# Airstream Service Bulletin

Bulletin Number: 198

Product Line: **Model Year 2023 & 2024 Basecamp 16', 20' & REI**

Subject: **Suburban Water Heater Misfire**

Install the DC/DC converter (part number 514386) by connecting the following wires:

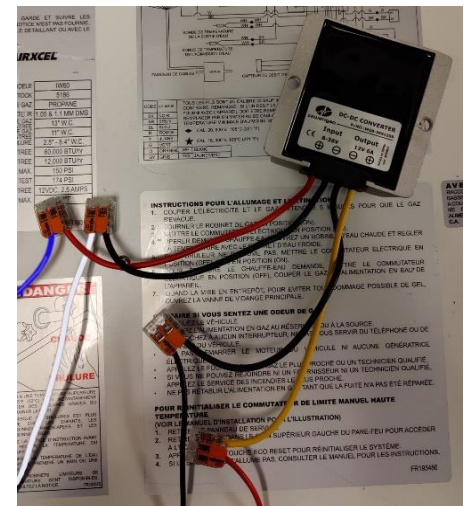
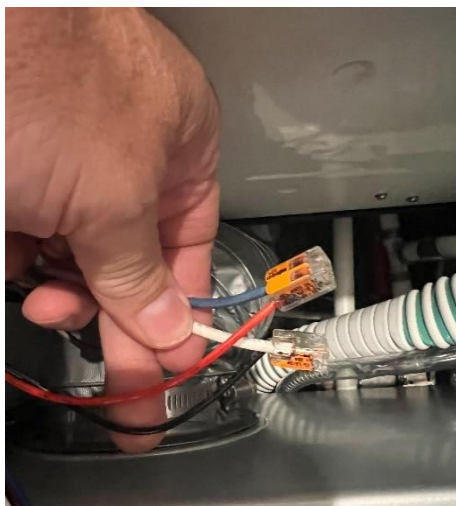
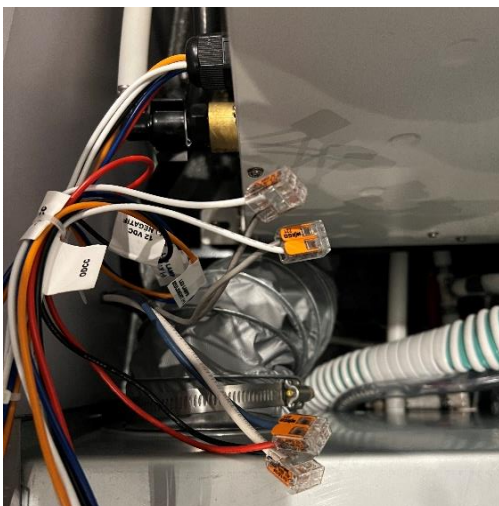
Airstream has found that some Basecamps with the Suburban IW60 water heater, which have been upgraded to Lithium batteries, may experience a failure in the water heater firing, due to spikes in voltage. If you have a Suburban water heater that fails to light, but does so when power to the water heater is cycled, please conduct the following procedure to correct the issue. This failure typically occurs directly after disconnecting the battery, but could happen at other times. If a complete power cycle allows the water heater to function properly, installing a DC/DC converter (part number 514386) to regulate the voltage output to a normal 12 volt range, will eliminate any spikes.

With the battery disconnect turned off, locate the positive blue wire and negative white wire for the furnace.

1. Connect the blue power wire to the input red wire.
2. Connect the white ground wire to the input black wire.
3. Connect the red wire to the output yellow wire.
4. Connect the black wire to the output black wire.

Using two, #8 3/8" screws (part number 320078), attach the DC/DC converter to the inside of the bench seat. Close the top and reinstall the screws to attach the top to the base. Turn the battery disconnect back on and cycle the water heater to test.
